Addendum No. 3

Project: **Beaumont Independent School District New Transportation Center**

Date: **October 23, 2024**

All bidders/proposers are herewith notified of the following additions, deletions, changes or clarification to the drawings dated August 23, 2024, and shall be acknowledged as received on the proposal form.

SHEET NAME:
**ELECTRICAL
POWER FLOOR
PLAN**

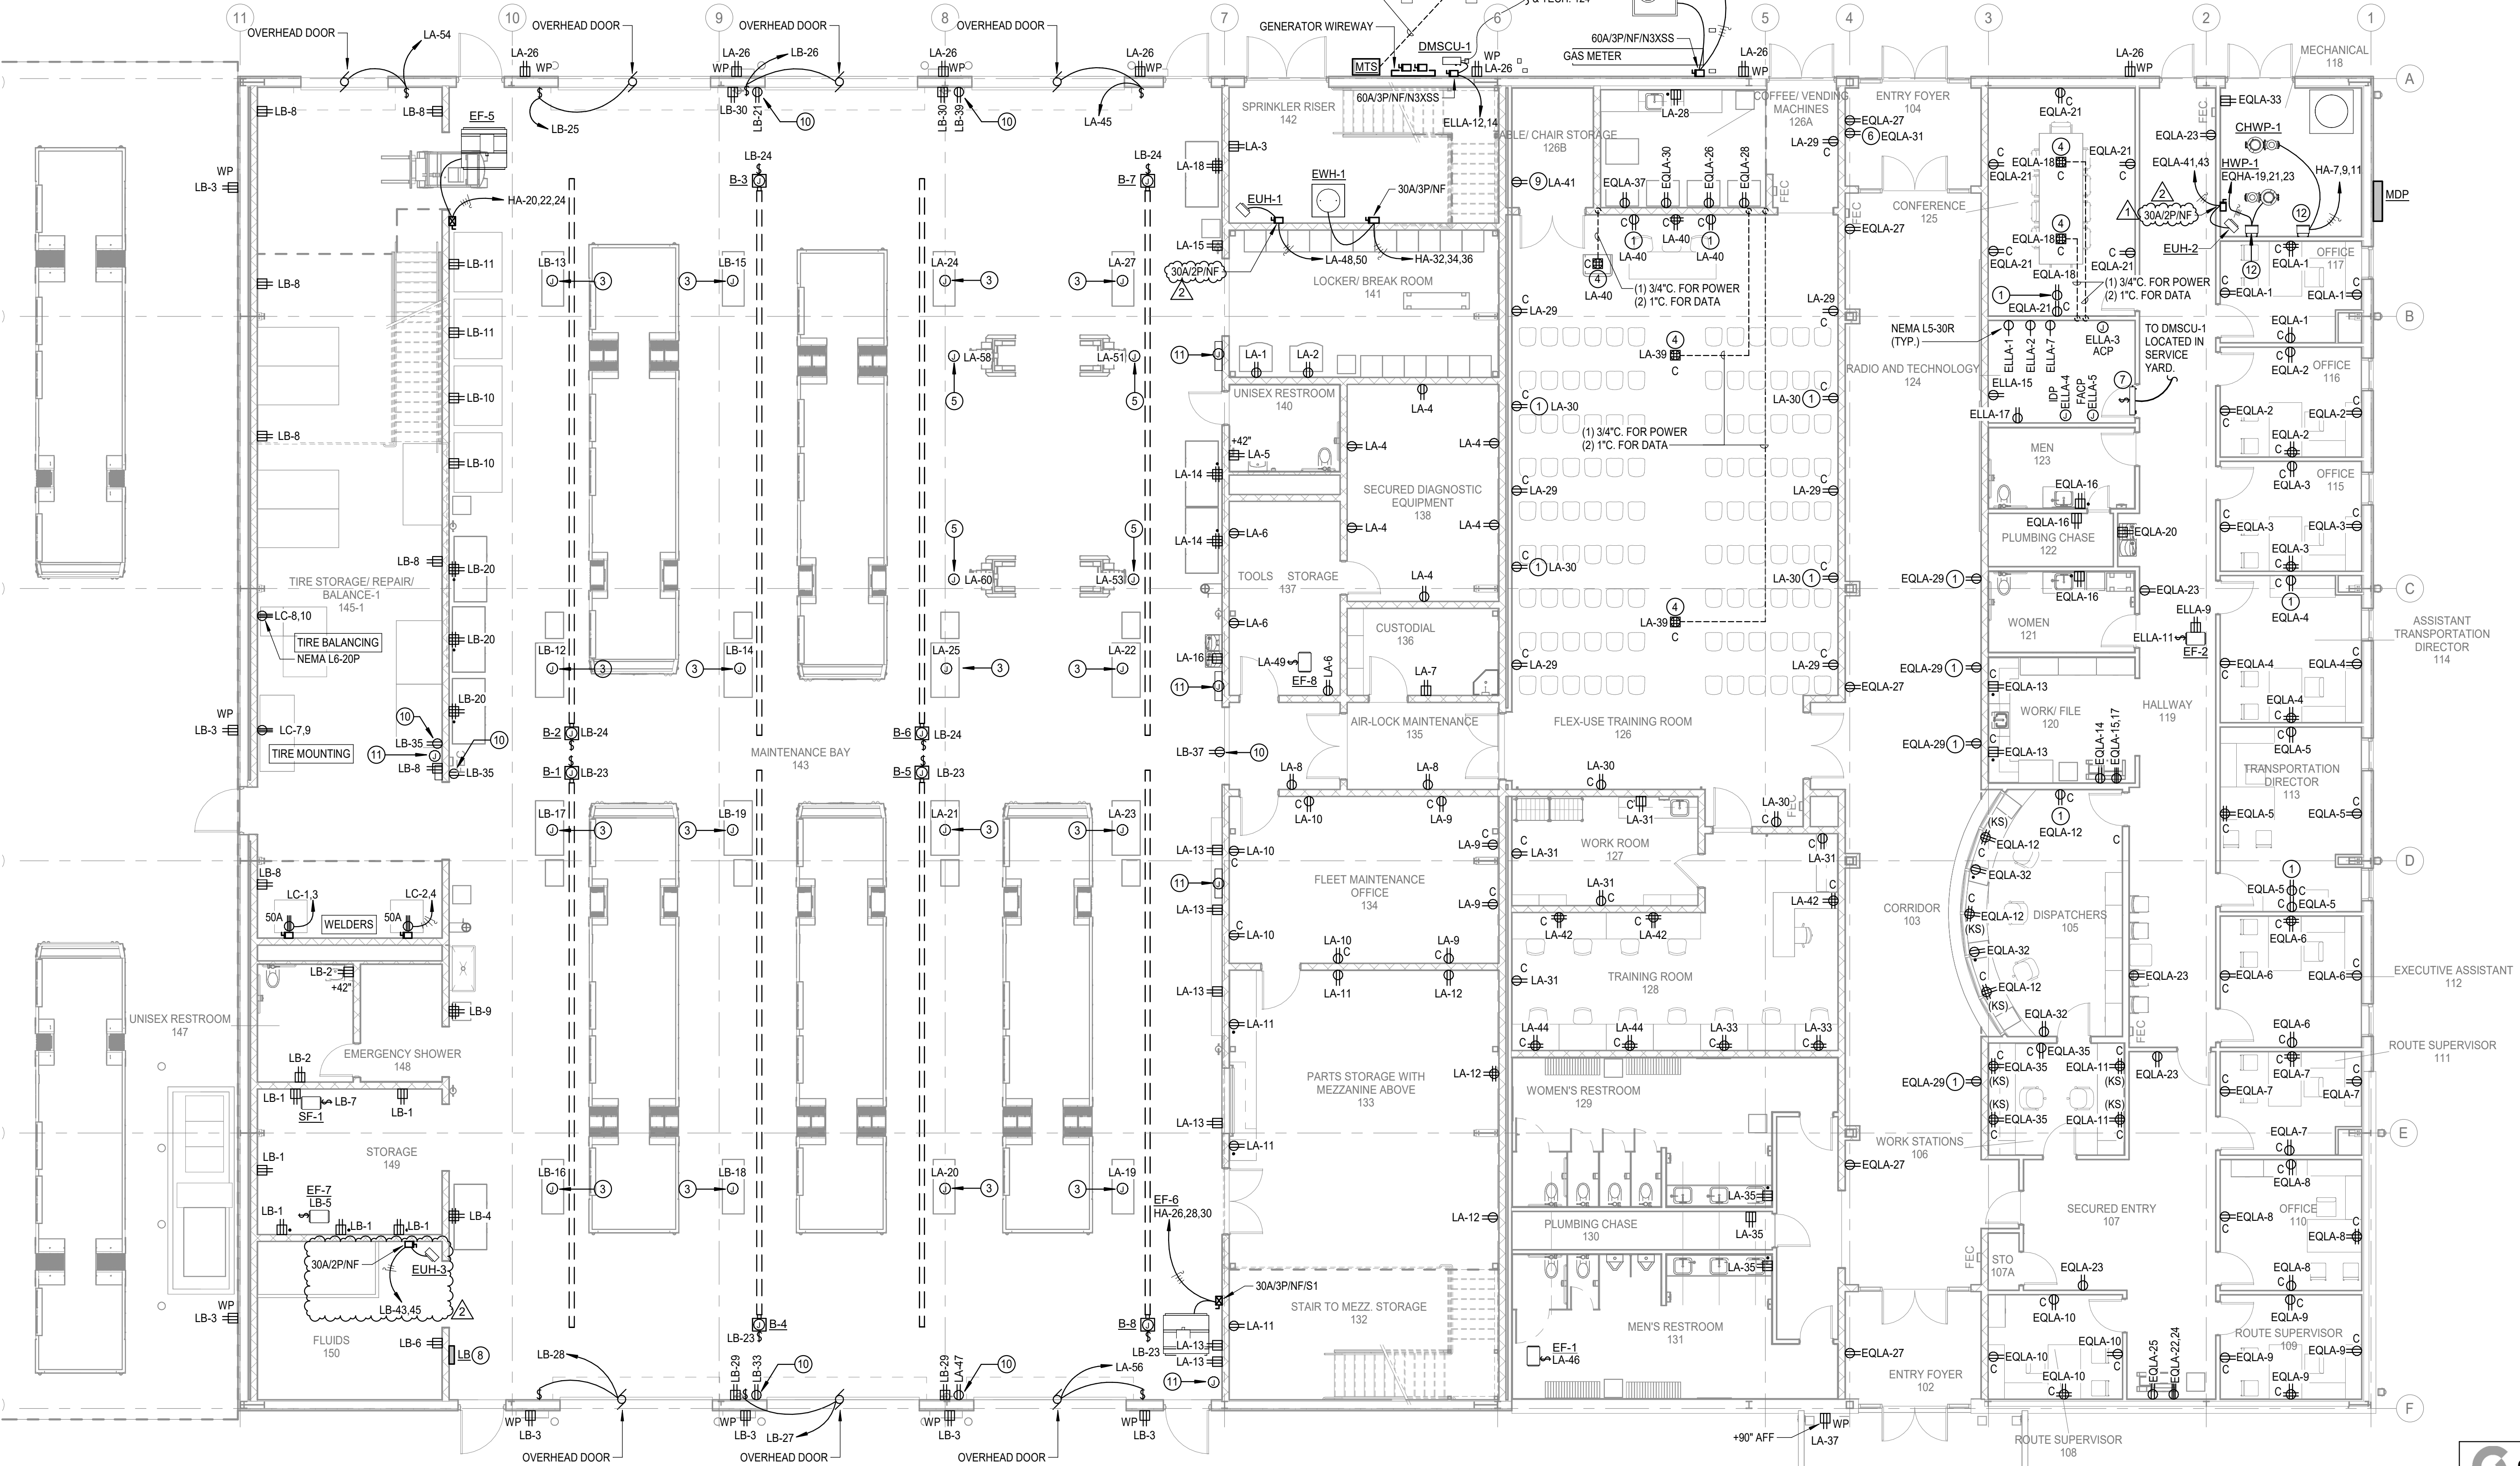
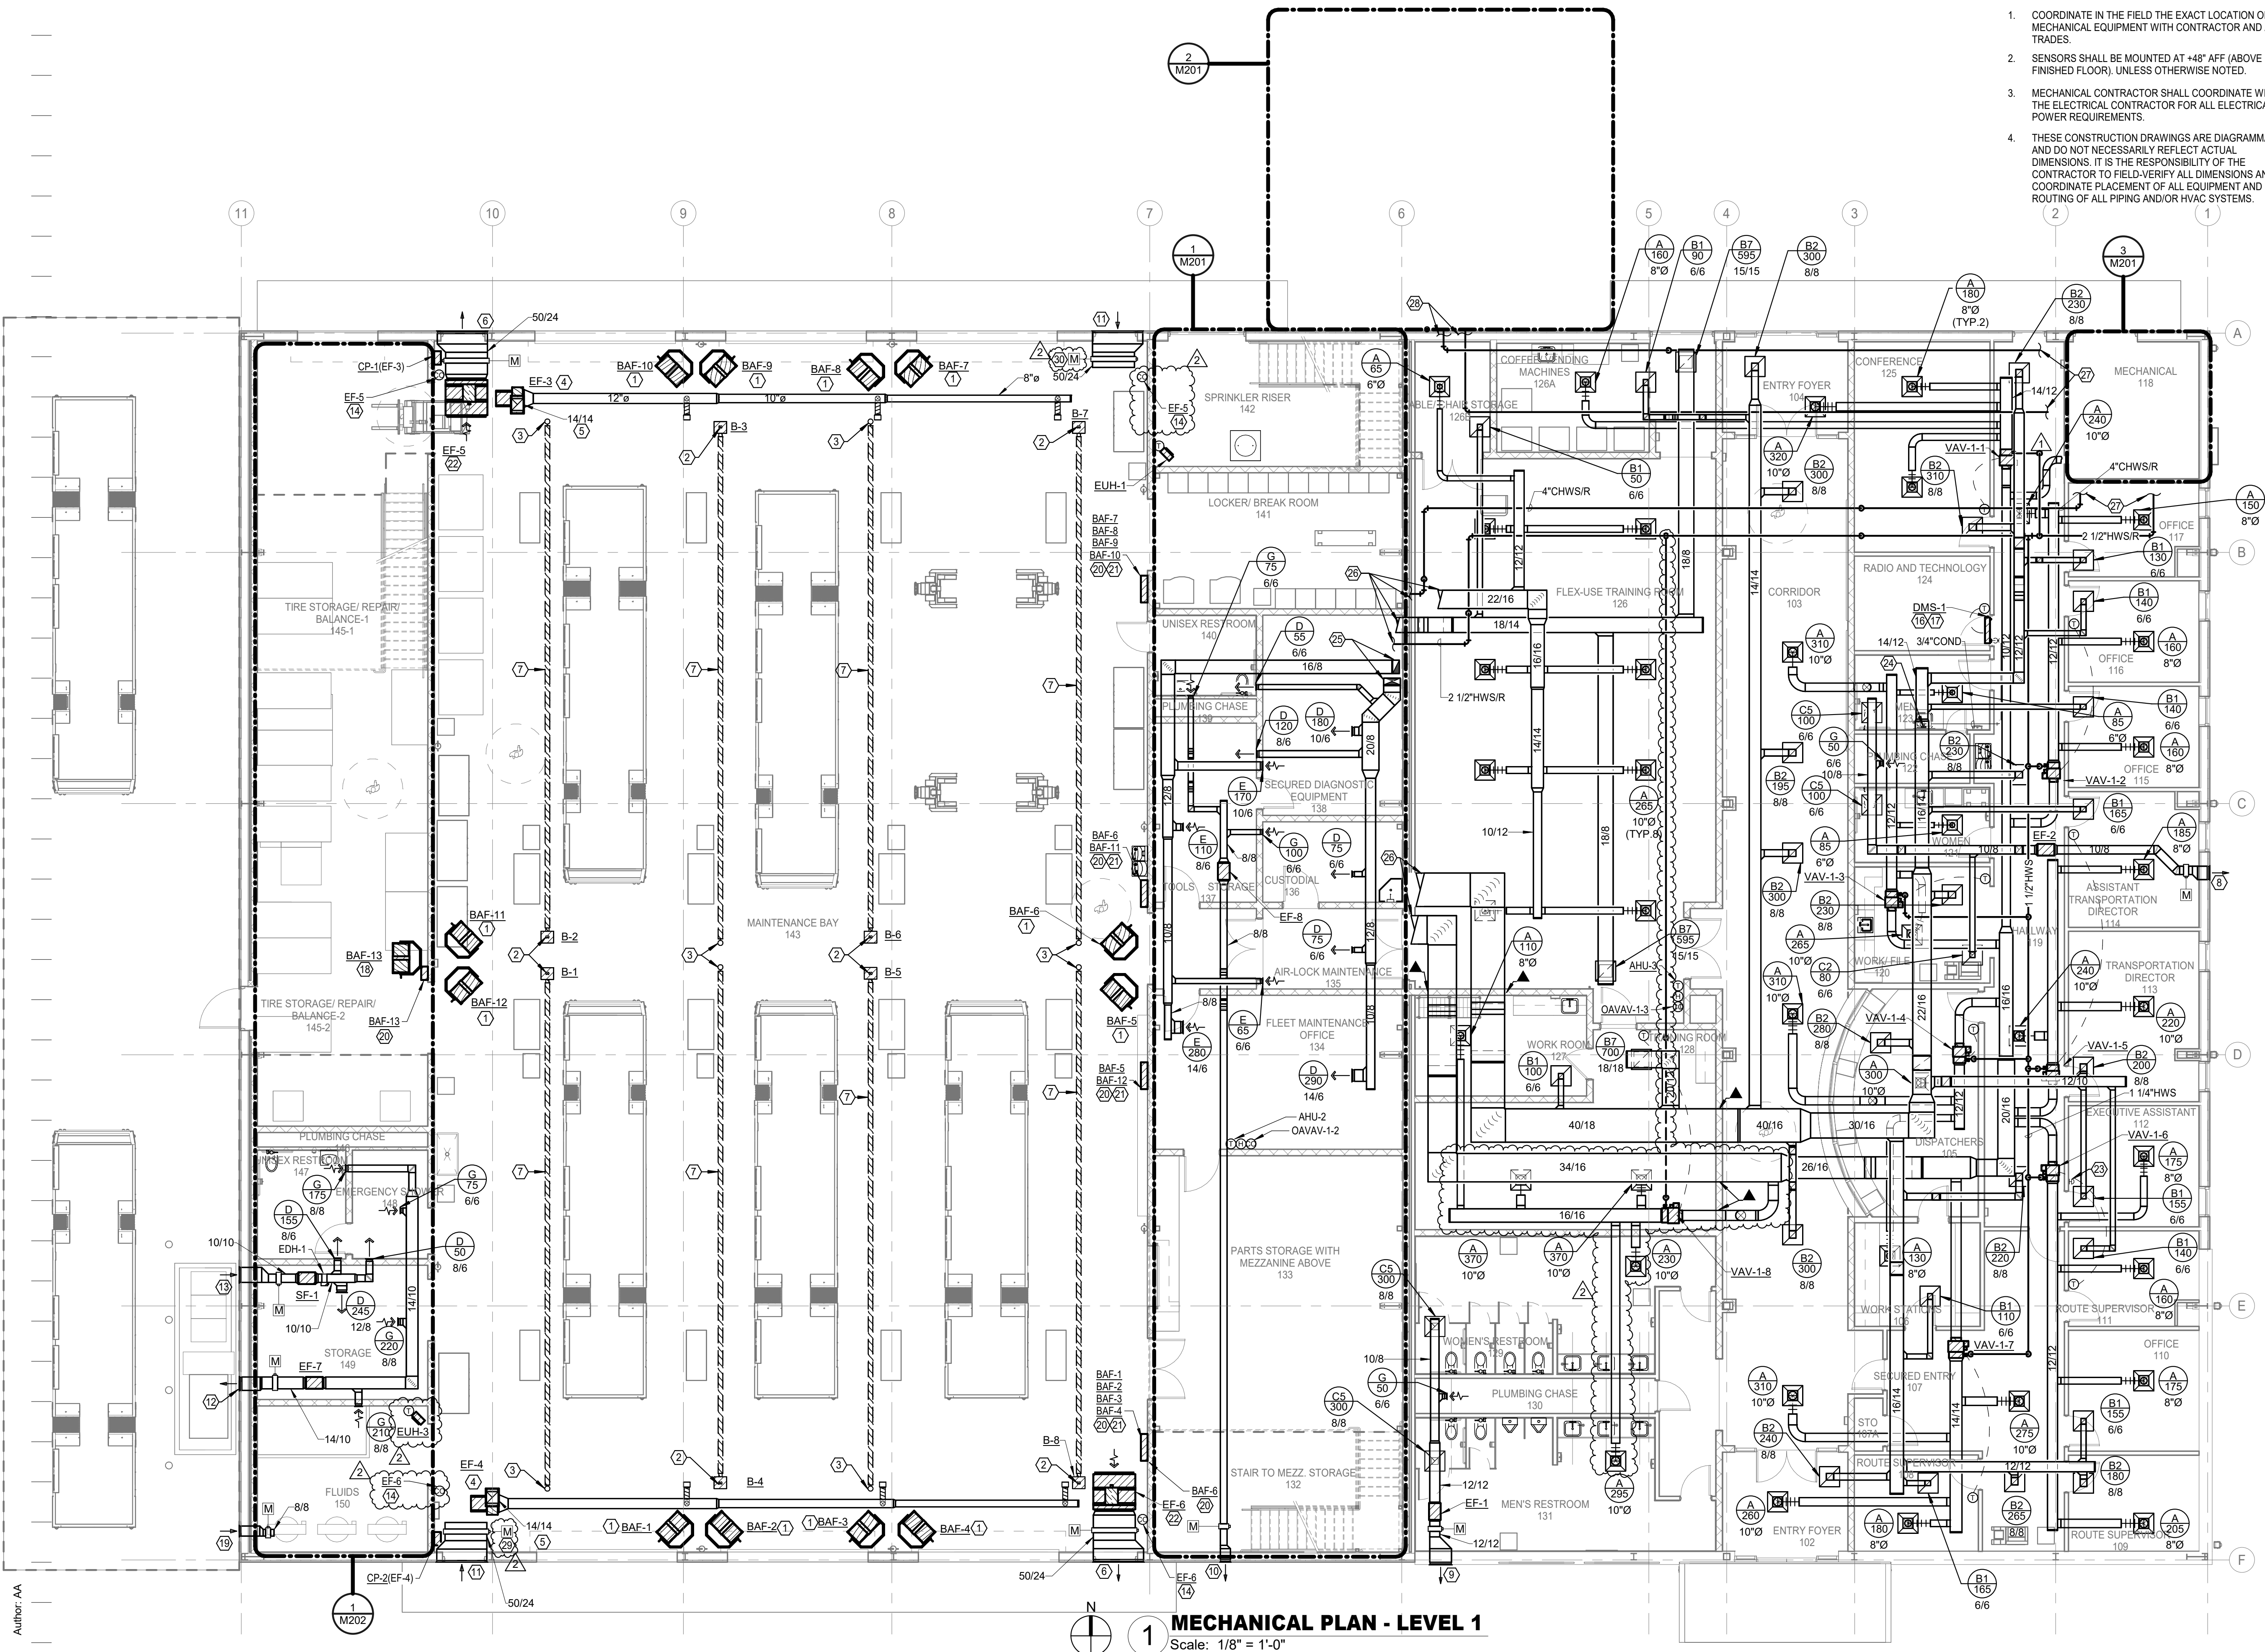
1. Sheet E300 – ELECTRICAL POEWR FLOOR PLAN
 - a. Route 2#10, 1#10G., 3/4"C. from panel LB to EUH-3. Provide with 30A/2P/NF disconnect switch and make final connection.

- b. Sprinkler Riser, revise disconnect for EUH-2 to 30/2P/NF.
 - c. Mechanical 118, revise disconnect for EUH-2 to 30/2P/NF.
 - d. Replace sheet in its entirety.

SHEET NAME:
**MECHANICAL
ENLARGED PLAN**

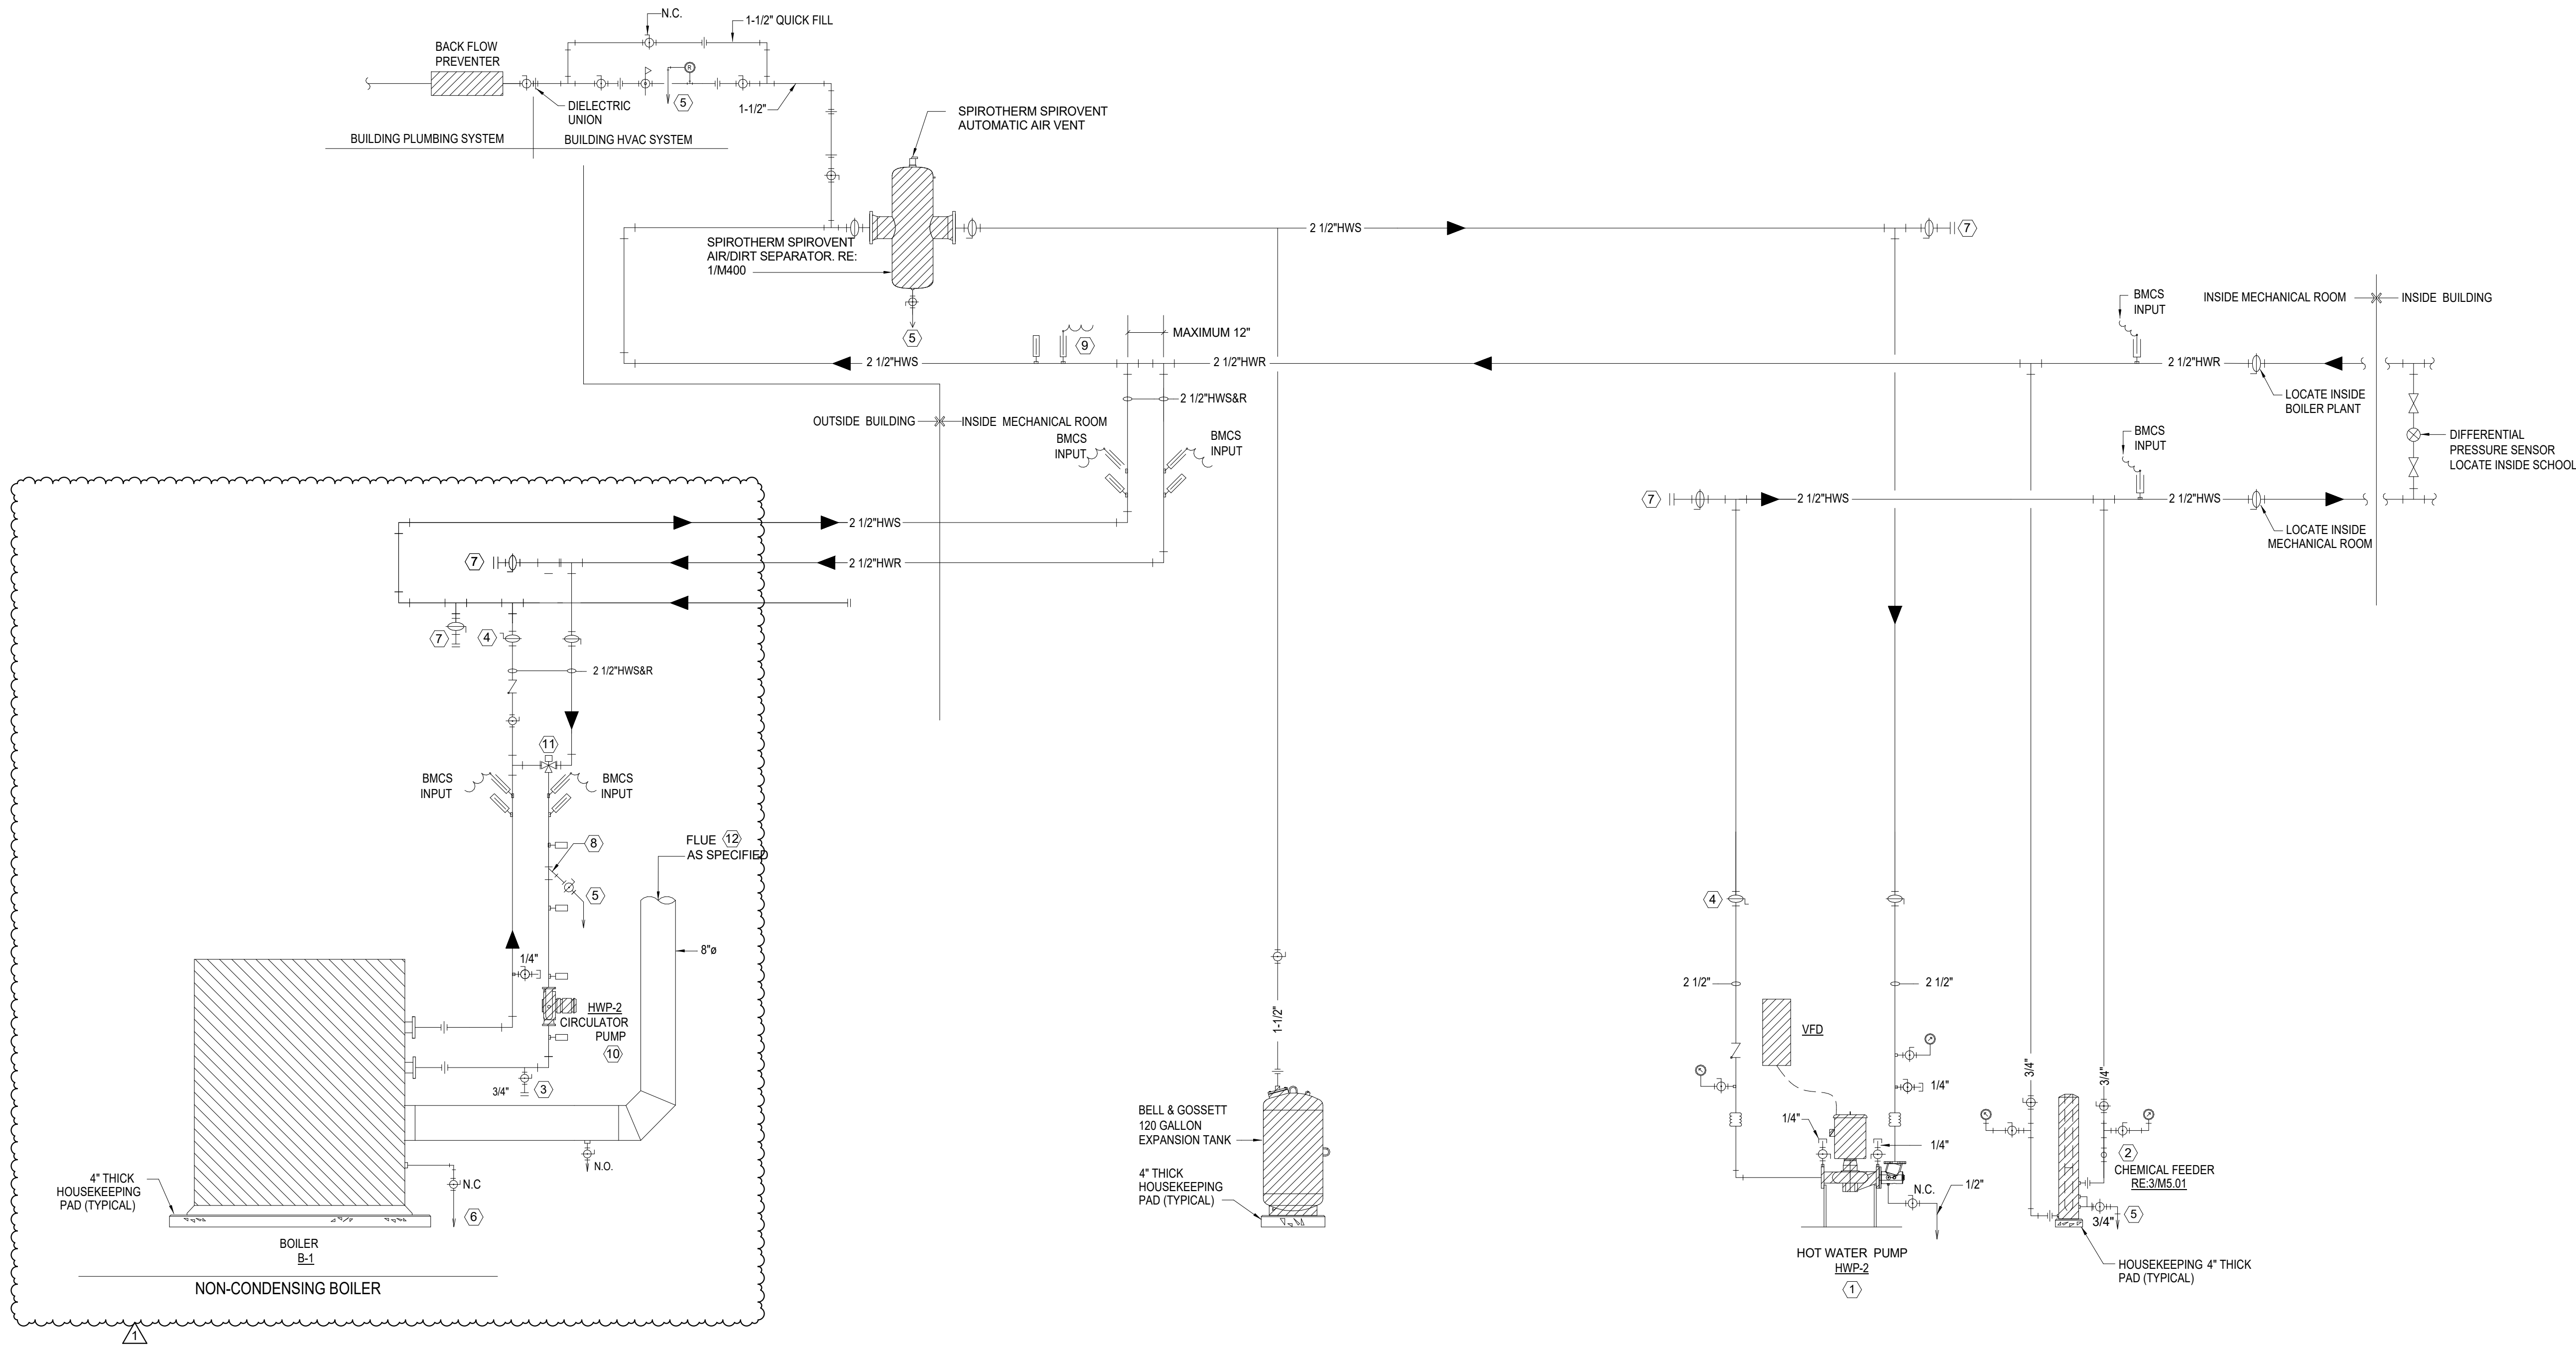
- b. Modify ductwork on VAV-1-9 in MECHANICAL 201.
 - c. Replace sheet in its entirety.
8. SHEET M202 – MECHANICAL ENLARGED PLAN
 - a. Relocate EF-9 in COMPRESSOR ROOM 206.

- b. Replace sheet in its entirety.
9. SHEET M302 –MECHANICAL PIPING DIAGRAM
 - a. Revise piping schematic for the hot water system.
 - b. Replace sheet in its entirety.
